ADDENDUM NUMBER 2
City Hall/Thalian Hall HVAC Upgrades
PB-EDI-0421
MARCH 31, 2021

City of Wilmington
City Hall / Thalian Hall
HVAC Upgrades

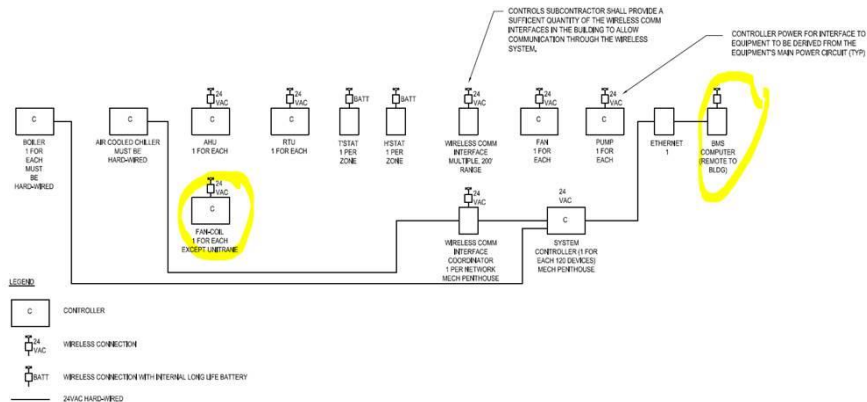
13. Confirming the New fan coils are on the wireless system? See above and below drawing attached snip.

Response: The new or existing fan coils are on the wireless system. Refer to CVR cover sheet, Base Bid note 1.

**CONCEPT
 ACCESS
 WALKWAY**

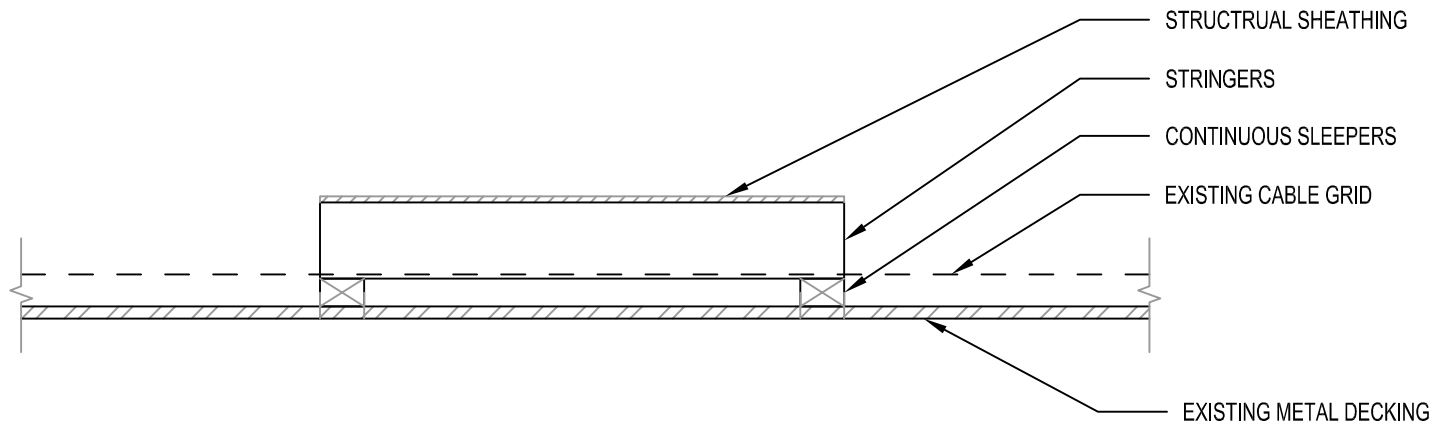
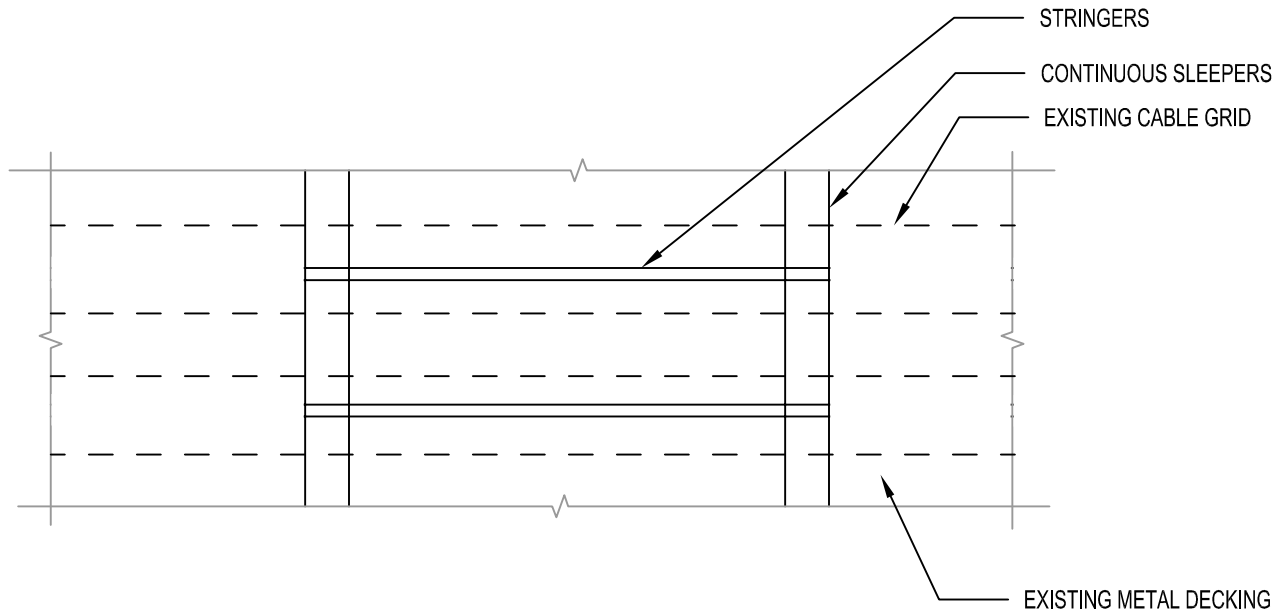
3. In attempt to keep bids level with all GCs, can we clarify what type of walkway system would be required to protect the curtain cabling system?

Response: *The contractor is responsible for providing temporary access at the fly grid attic area as needed for construction activities. This is considered the contractor's means and methods. We have provided a concept sketch of a possible construction access way. See attached.*
